Document type
Stage 2 Acoustic Report

Date
August 2022

25 TAVISTOCK PLACE

ACOUSTIC STAGE 2 REPORT

Figure 3 - Minimum Head detail requirement

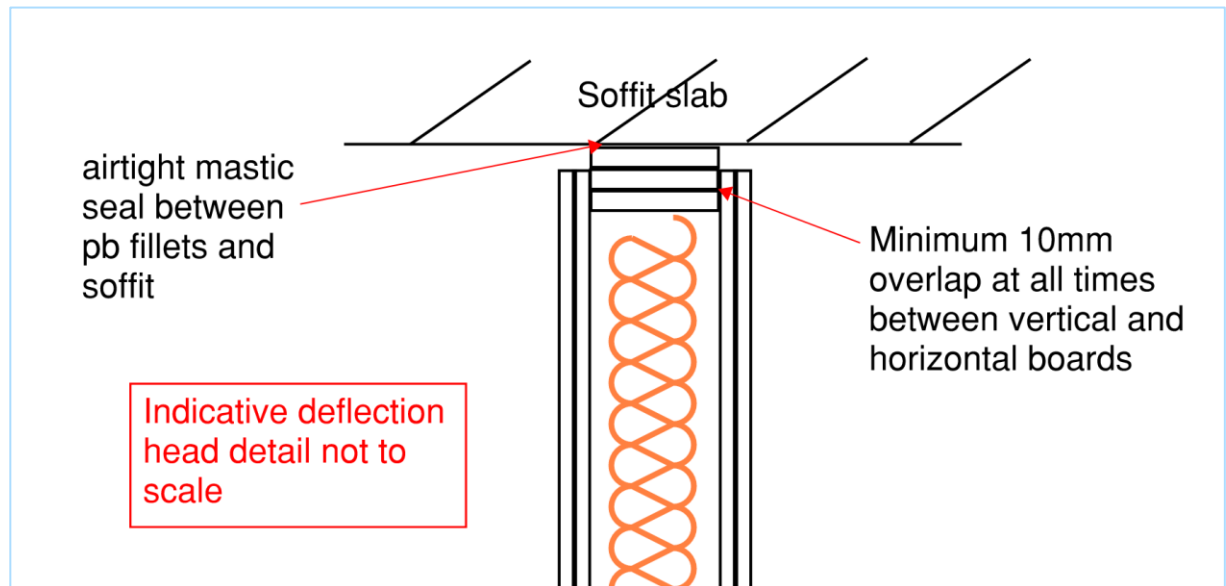
The head detail, where separating partitions meet the underside of the concrete slab, will be a particular weak point acoustically where the soffit is exposed. This will therefore be a key detail in

achieving the required sound insulation performances between spaces, especially where $D_{nT,w}$ 48 is required.

The detail shown in Figure 4 is capable of controlling flanking across the head of the partition provided the workmanship is excellent and the gaps between plasterboard fillets and soffit slab are sealed airtight with mastic.

On some jobs partitions with this detail have failed by as much as 9dB during testing. When the contractor subsequently sealed the gaps airtight with dense mastic they managed to improve them to a pass during retests

Figure 4 - BG recommended head detail (steel angles)

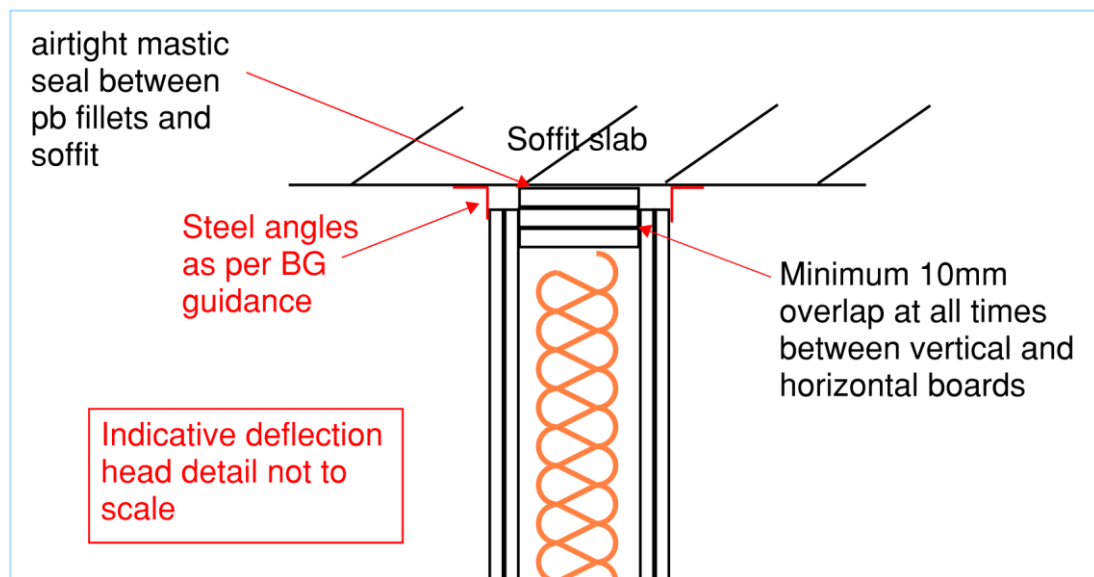
It should be noted that British Gypsum recommend that steel angles are used either side of the partition to achieve the required performance (see Figure 5). Specifying these steel angles would reduce risk of failure during testing.

Figure 6 - First Floor Semi-Private Office

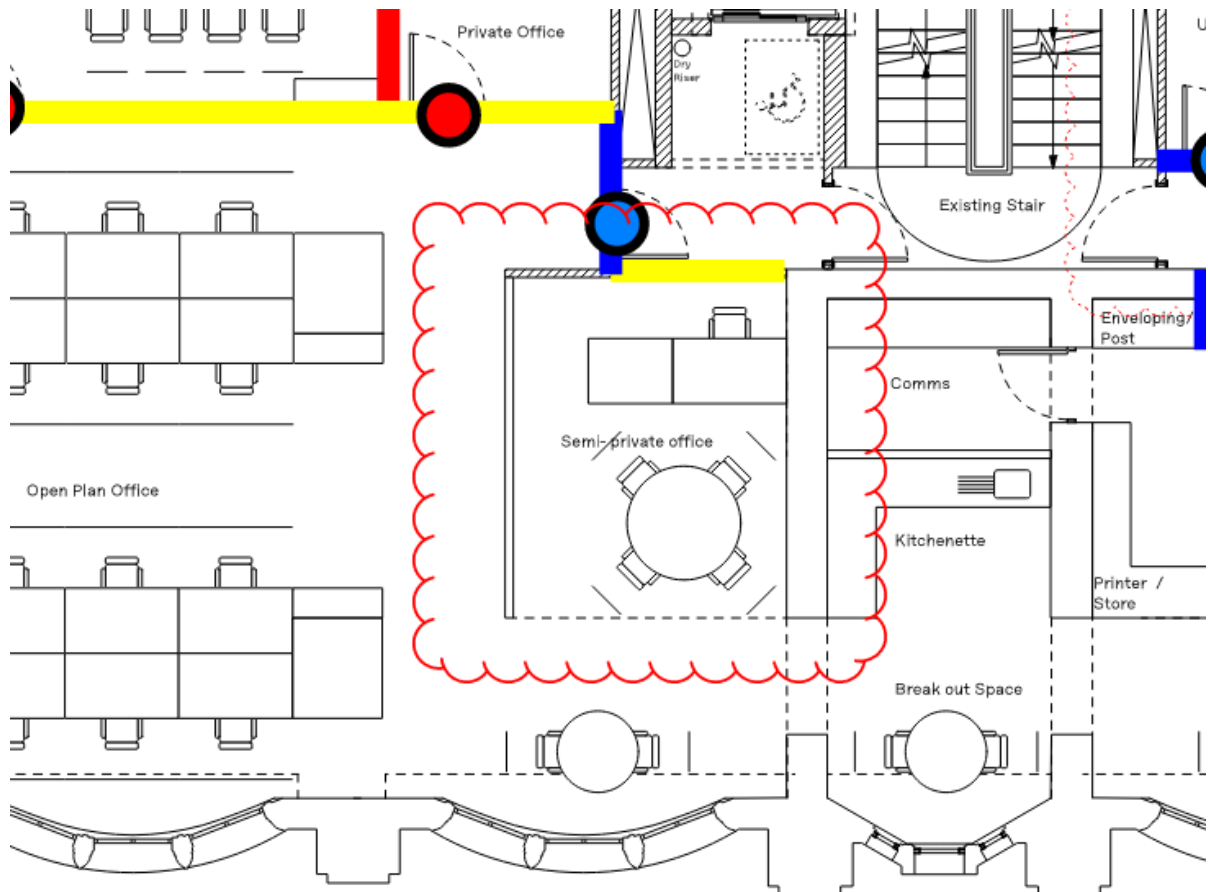
Current plans propose a semi-private office on the first floor. It is worth noting that any privacy will not be achieved between this office space and the surrounding open plan office and kitchenette areas. It is worth considering adding a partition to enclose the space if privacy is required.

Project Title:		25 Tavistock Place	
Project No:		RUK202200331	
Sketch No:		Lower Ground Floor	
Title:		Internal sound insulation requirements	
Scale:		Not to scale	
Eng:	Rev:	Date:	Checked:
MF	-	28/07/2022	ST

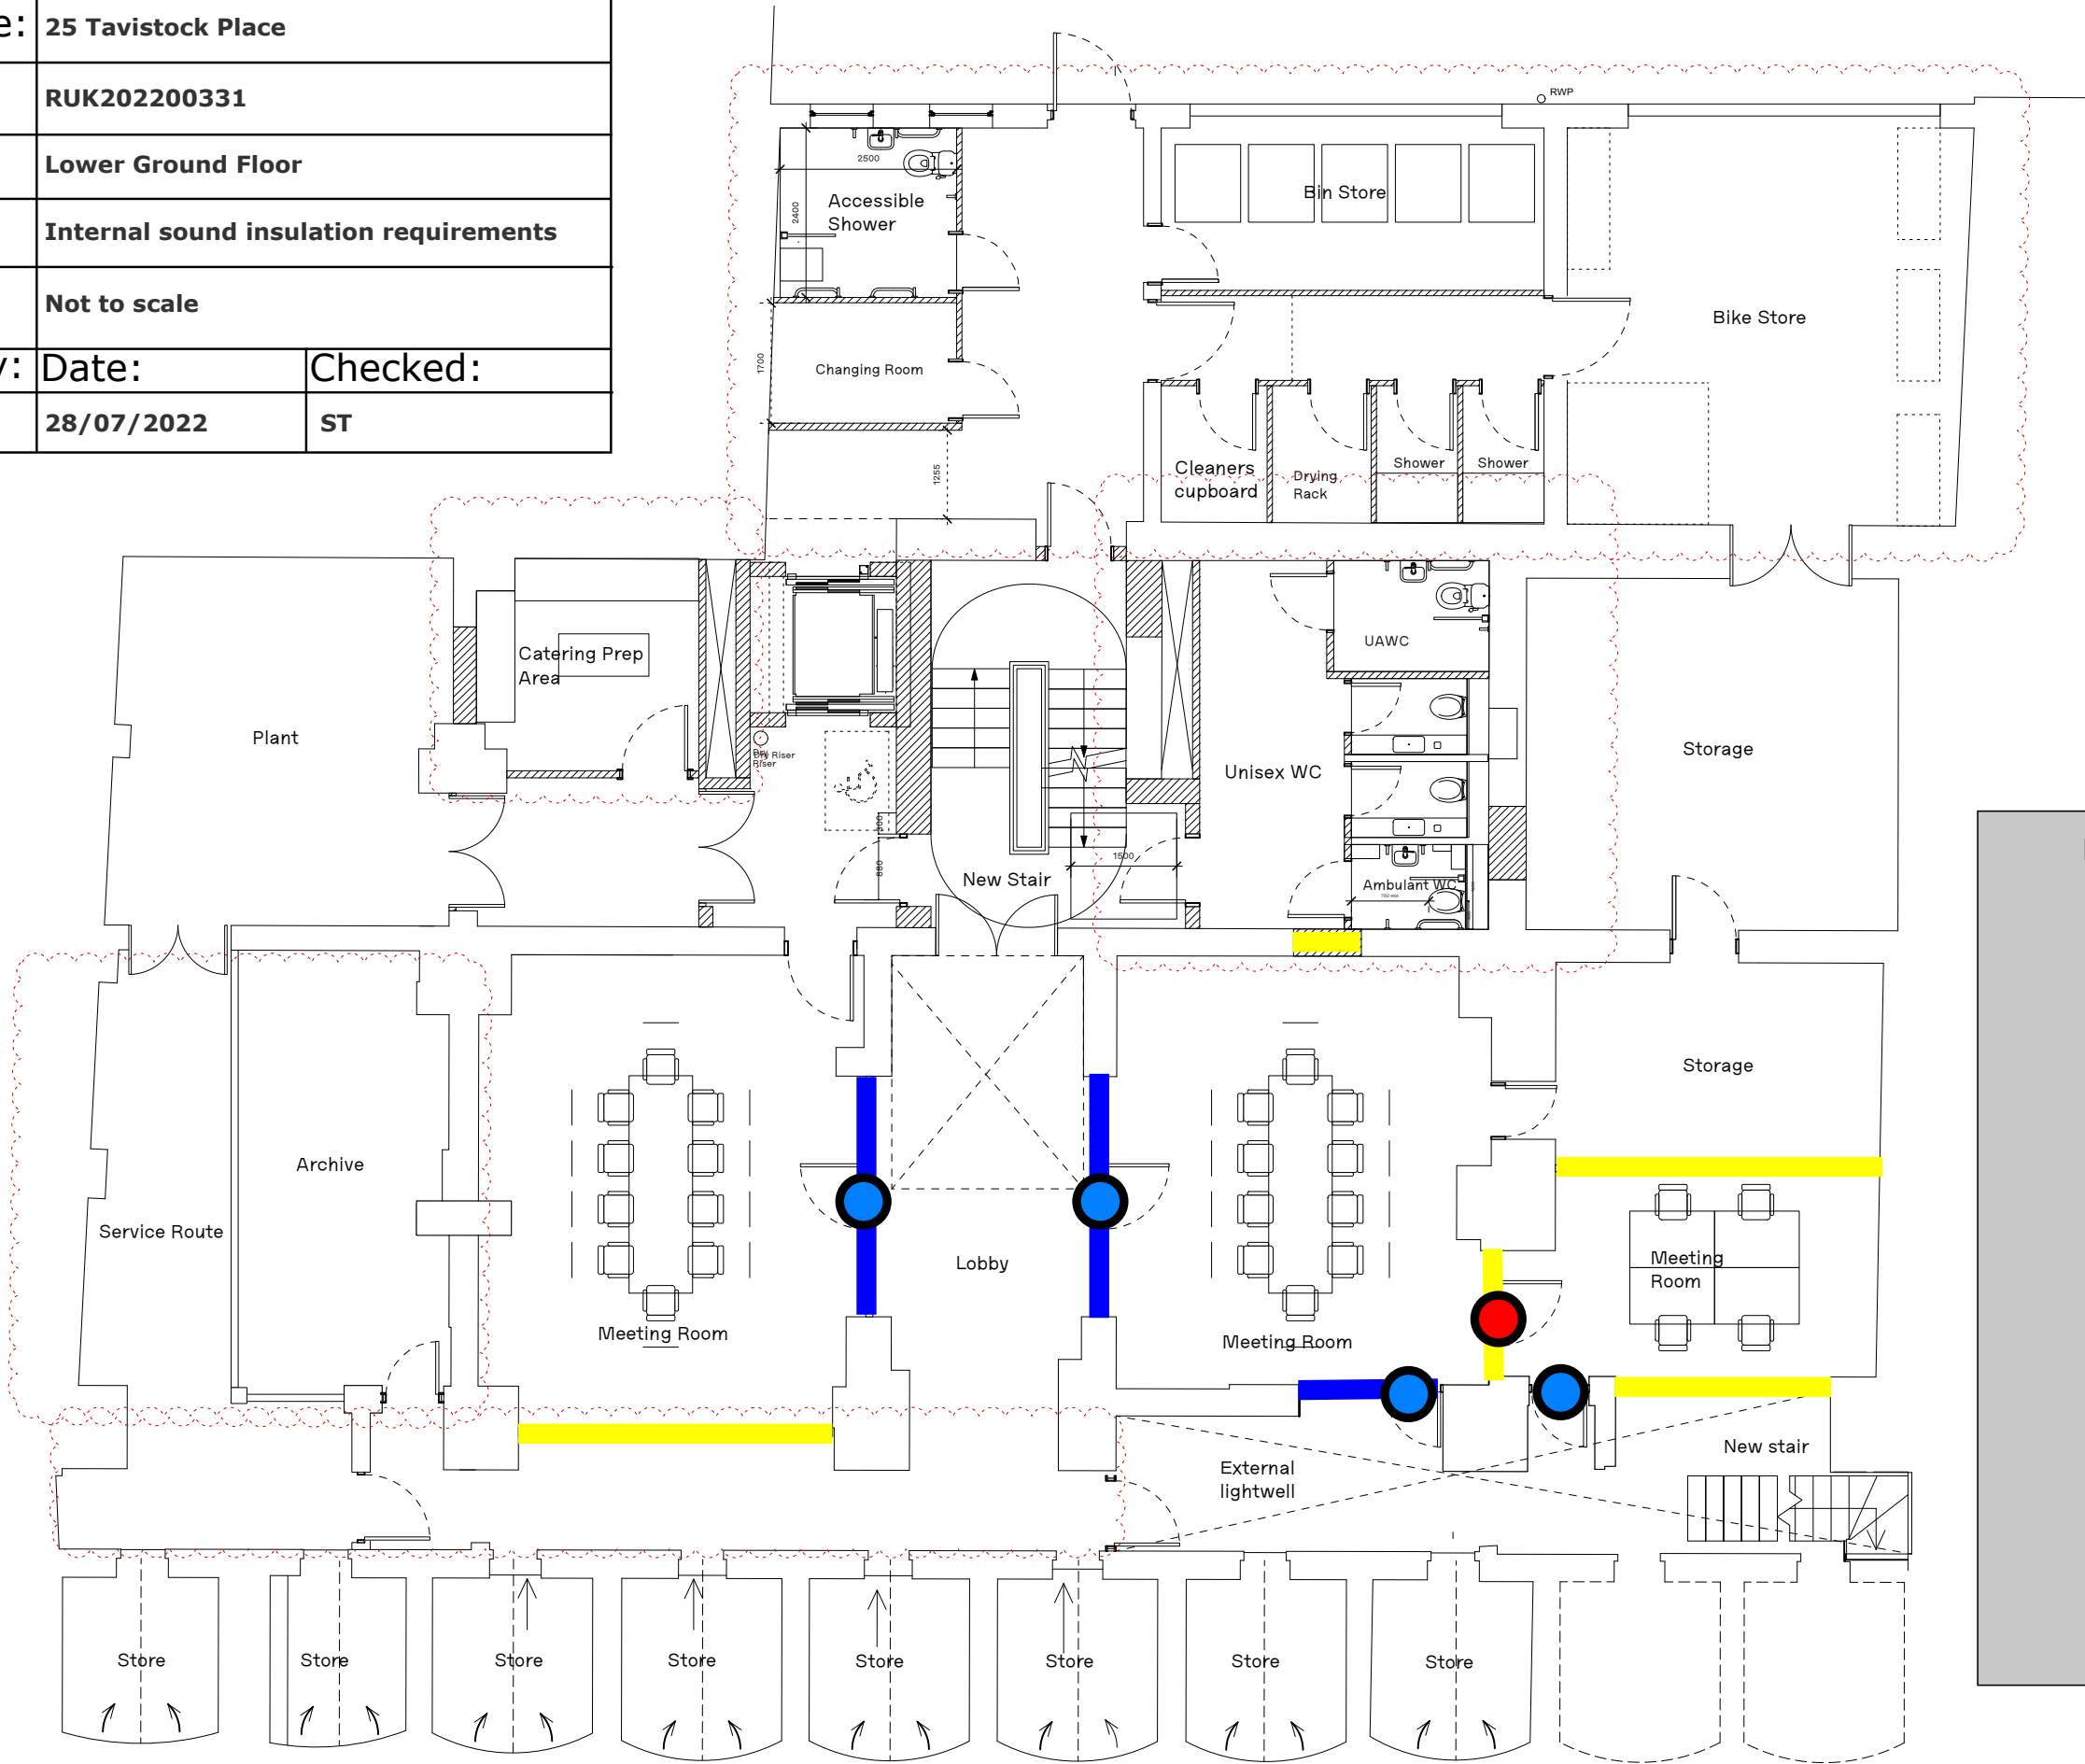
Mark-ups are provided in Appendix 3, showing the sound insulation requirements for partitions and doors, in terms of the laboratory rating (R_w).

-  **R_w 40 dB partition**
-  **R_w 45 dB partition**
-  **R_w 56 dB partition**

-  **R_w 30 dB doorset**
-  **R_w 35 dB doorset**

Project Title: 25 Tavistock Place			
Project No: RUK202200331			
Sketch No: Ground Floor			
Title: Internal sound insulation requirements			
Scale: Not to scale			
Eng:	Rev:	Date:	Checked:
MF	-	28/07/2022	ST

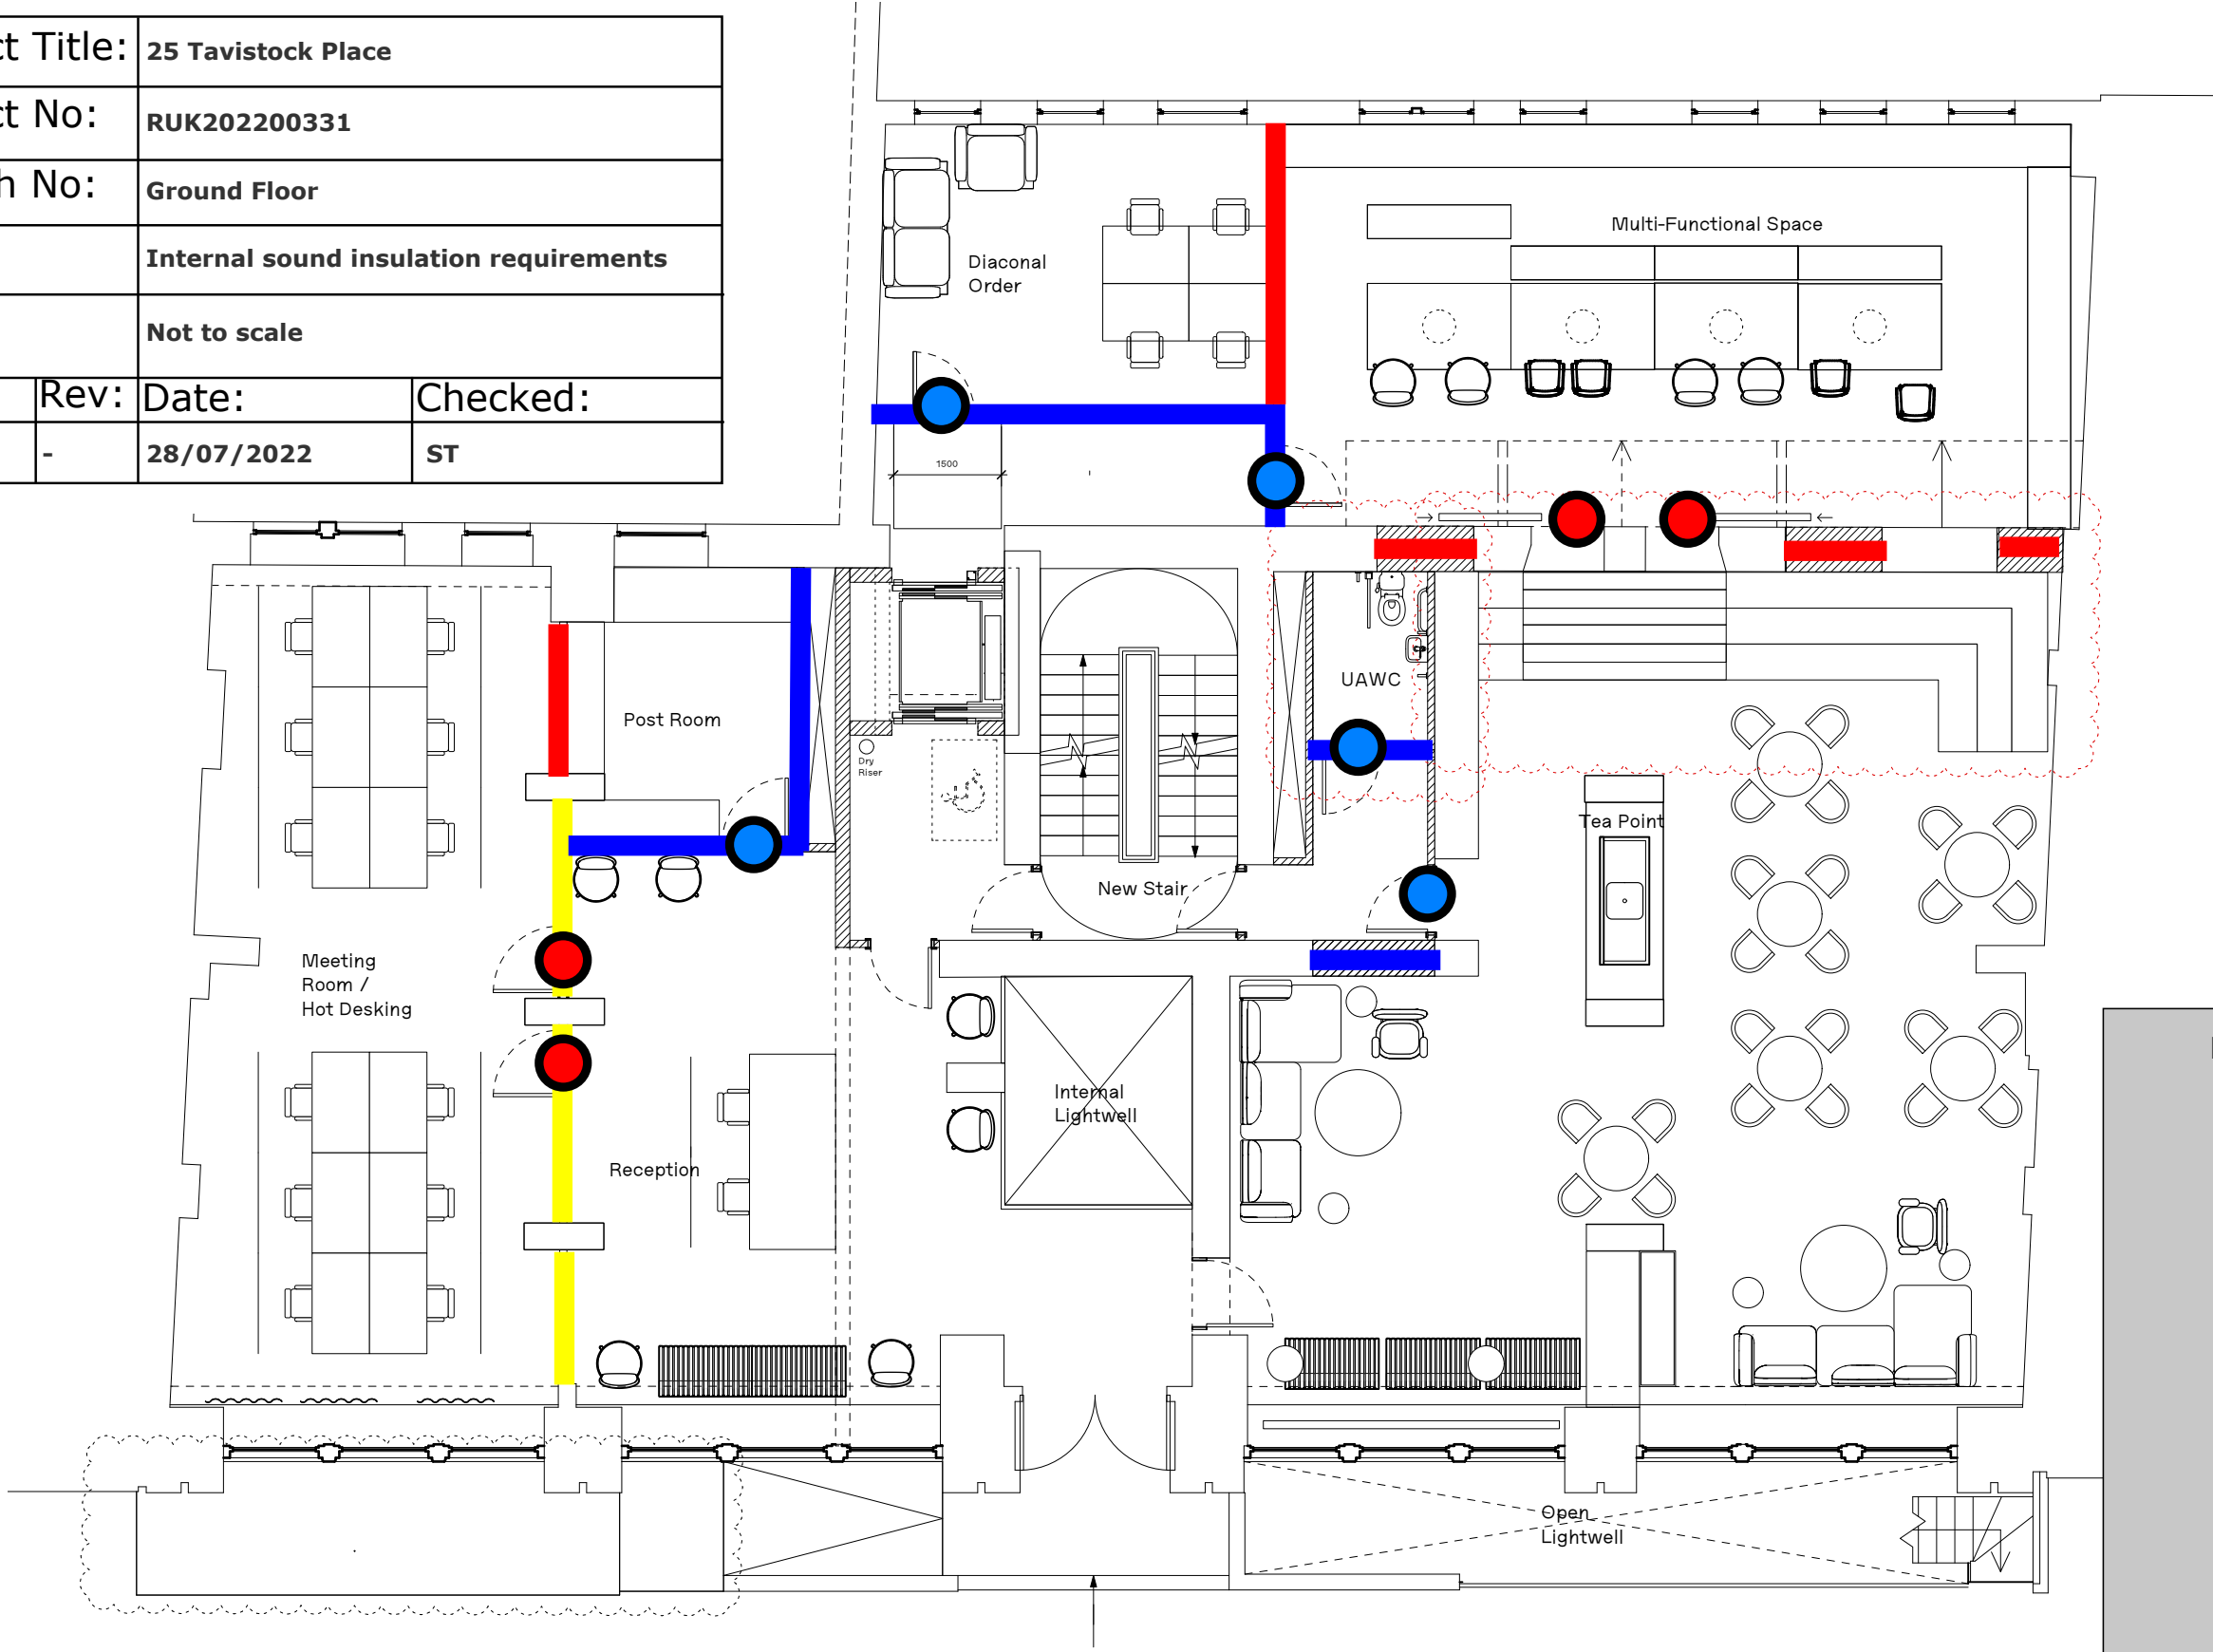
-  **R_w 40 dB partition**
-  **R_w 45 dB partition**
-  **R_w 56 dB partition**

-  **R_w 30 dB doorset**
-  **R_w 35 dB doorset**
